VERIFICATION OF INTERIM PERFORMANCE INDICATORS UNDER THE GUYANA-NORWAY REDD+ PARTNERSHIP

Monitoring Period:
1 October 2009 to 30 September 2010 – Year 1

REPORT No. 2011-9107

REVISION No. 02

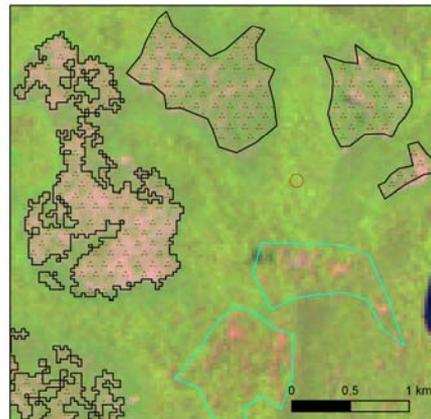
Section 7.0. We fully understand and agree that areas under SFM that adhere to forestry code practice should not be considered deforested. However, it could be useful if possible to see data on the extent of the area that currently has crown cover below the 30% limit without being classified as deforested.

RP: *Generally the spatial pattern of selective harvesting is discontinuous, so it is difficult to map these areas individually using the Landsat. The approach taken was to map the spatial extent of the harvest area rather than each area individually.*

The following example shows an area where harvesting has occurred and the general extent of the activity. For reference a 1 ha circle is also shown. This represents the MMU. Non-forest areas are also identified. These areas were non-forest as at 1990, so do not constitute change.

DNV: IMR has been updated and the response is deemed satisfactory

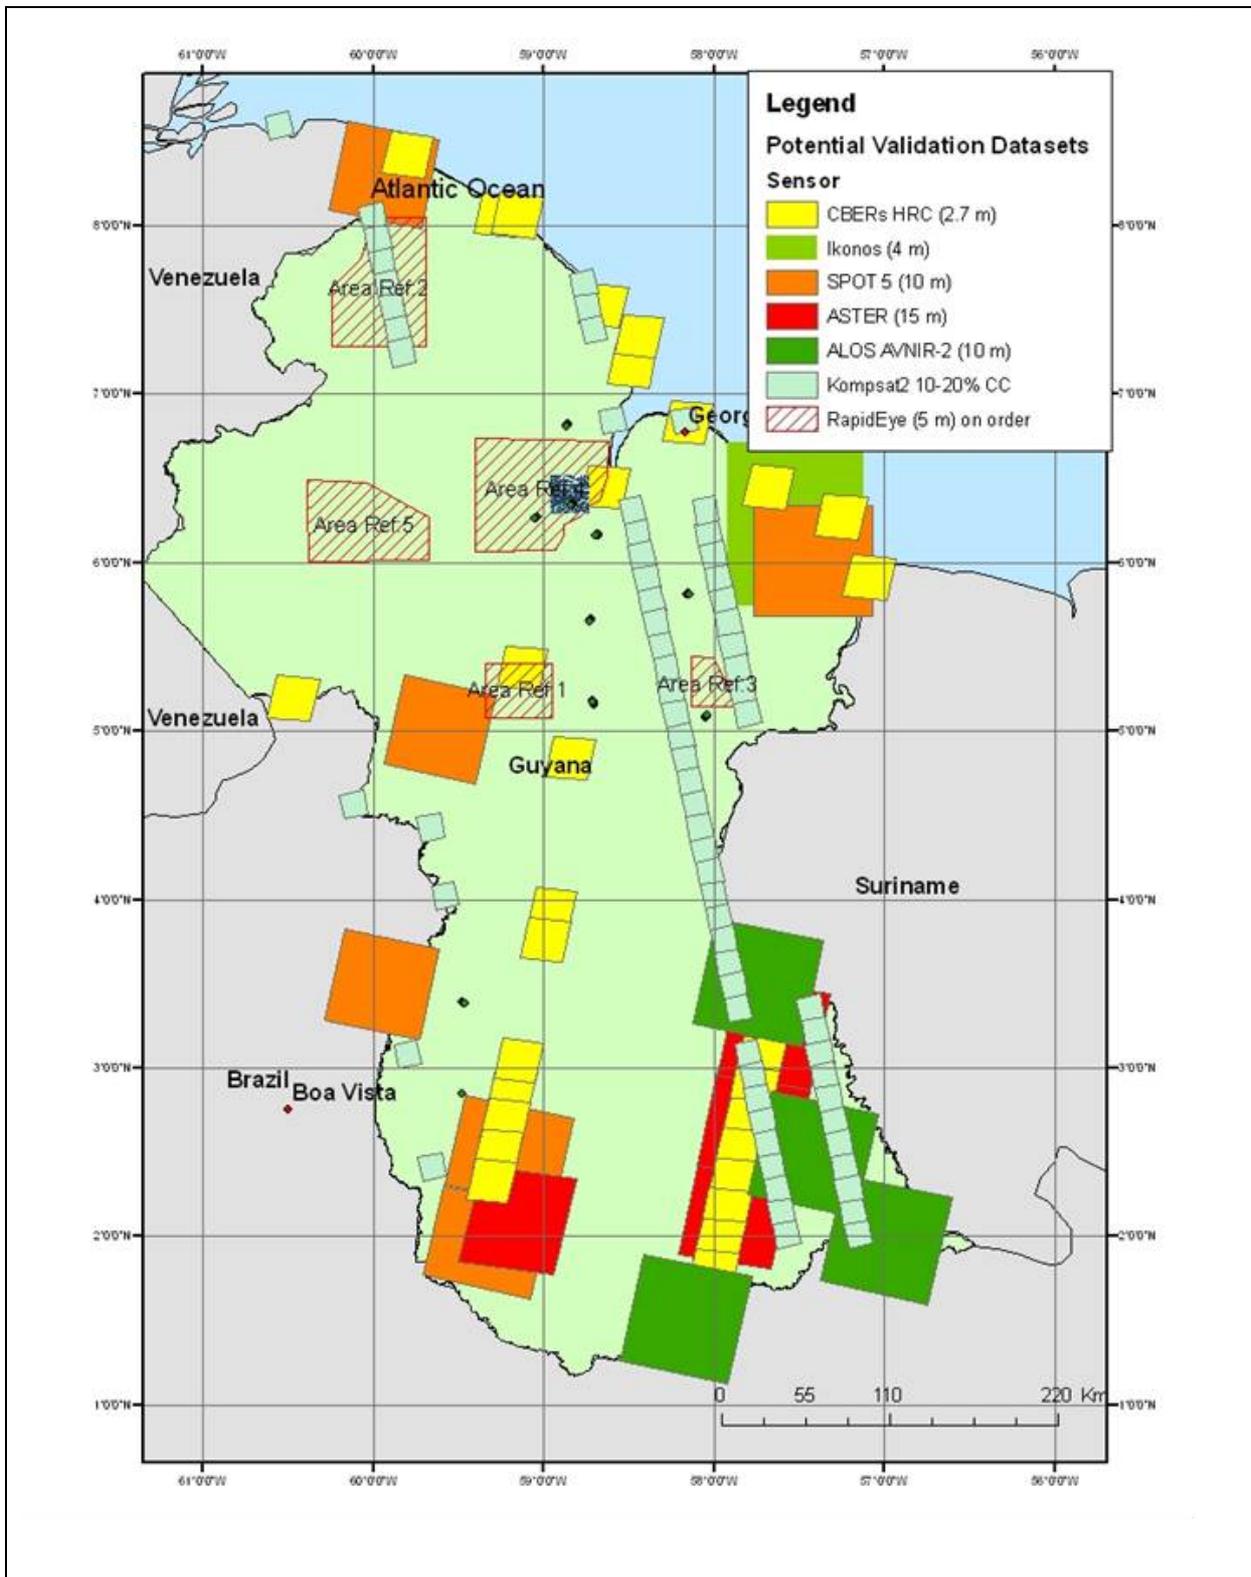
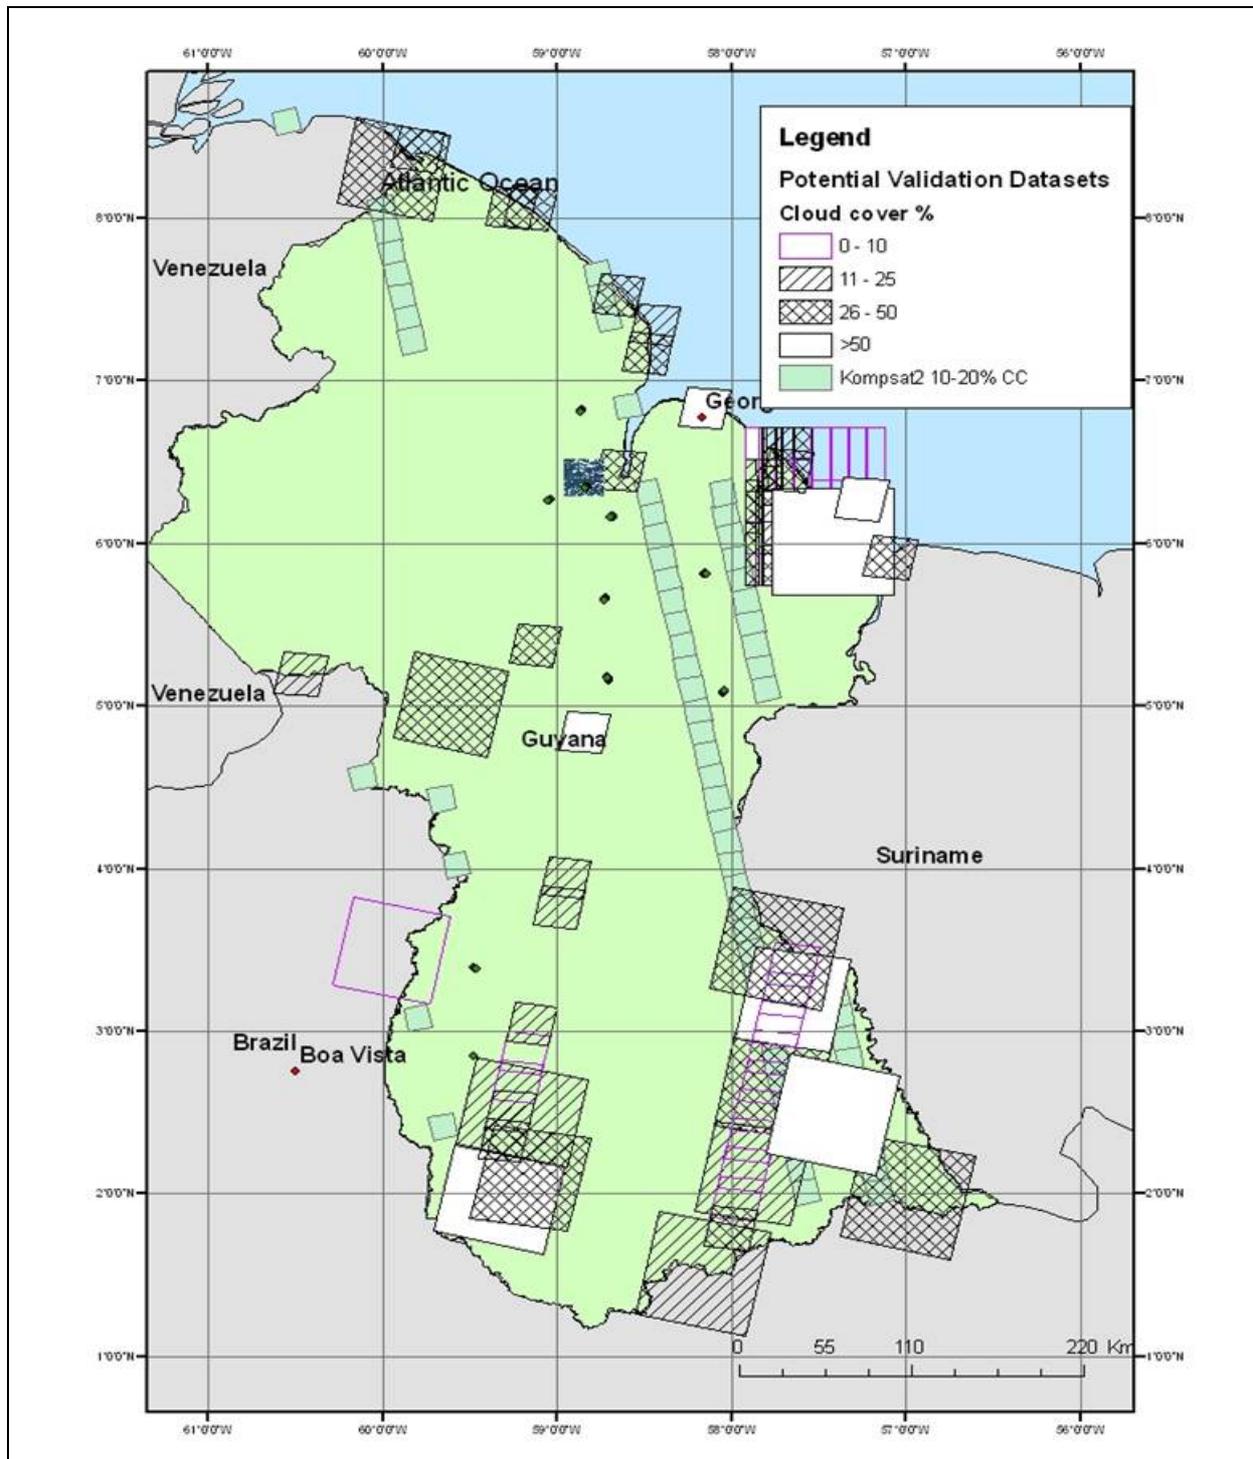
We would strongly recommend that significantly more focus is put on the uncertainties of the estimates. A fundamental improvement would be to provide the error estimates (standard error) of the deforestation rate estimates for the different periods, as well as for the change from the historical period to the reporting period. We expect the further validation work that is in progress will contribute to reduce the level of bias in the estimates of forest/non forest and in the change estimates.

Due to the lack of data it is unlikely that individual error margins can be assigned to each period. Given this limitation and the concentrated but fragmented nature of the change it would seem prudent to expend efforts on tasking high resolution coverage over the hotspot areas and make greater use of ground inspections.

DNV: An accuracy assessment is being carried out by Durham University.
